# Access Compliance Report

## Public Rights-of-Way

### (Curb Ramps)

Intersection ID: 14294	Main Street: EAST_BV	Cross Street: EUCLID_AV	Location: NE
ADA ID: F1F06BADE824	Ramp Type: Directional1	Initial Pass/Fail: Pass	Overall Compliance: No
Codes/Mitigation Info/Possible Solution		Field Measurements/Component Compliance	
Severity Score: 0.25

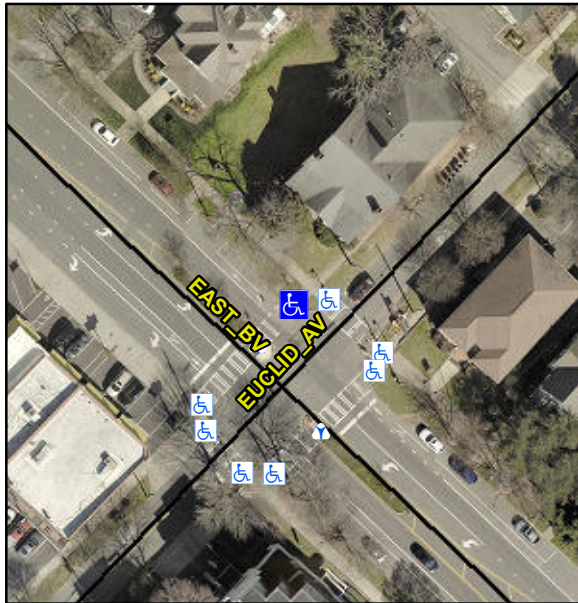
**LNDG SLOPE NEGATIVE**

**R304.2.2-Perp, R304.3.2-Para**

**Remove & Replace Landing.**
